# A d d e n d u m

Iowa Department of Transportation  
Office of Contracts

Date of Letting: November 18, 2014  
Date of Addendum: November 13, 2014

<b>B.O.</b>	<b>Proposal ID</b>	<b>Proposal Work Type</b>	<b>County</b>	<b>Project Number</b>	<b>Addendum</b>
101	07-2187-207	PCC PAVEMENT - GRADE & NEW	BLACK HAWK	NHSX-218-7(207)--3H-07 NHSX-218-7(211)--3H-07 NHSX-218-7(212)--3H-07 NHSX-218-7(213)--3H-07 NHSX-218-7(214)--3H-07 HSIPX-218-7(230)--3L-07 STP-S-C007(134)--5E-07	18NOV101.A03

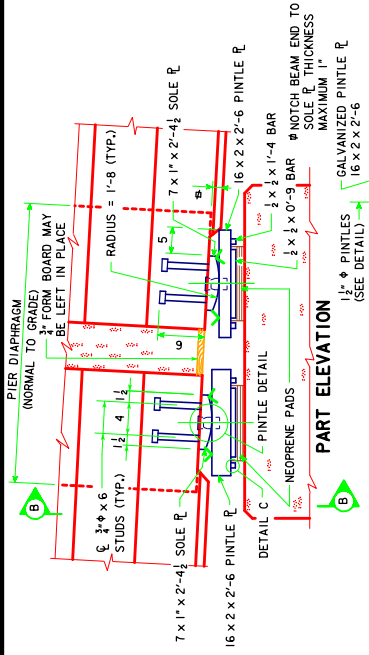
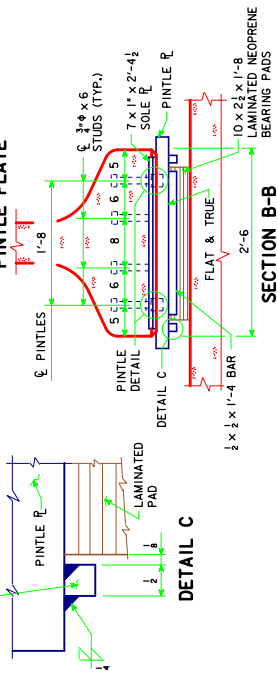
SHEET 18:

Replace Plan Sheet 18 with the attached Plan Sheet 18.
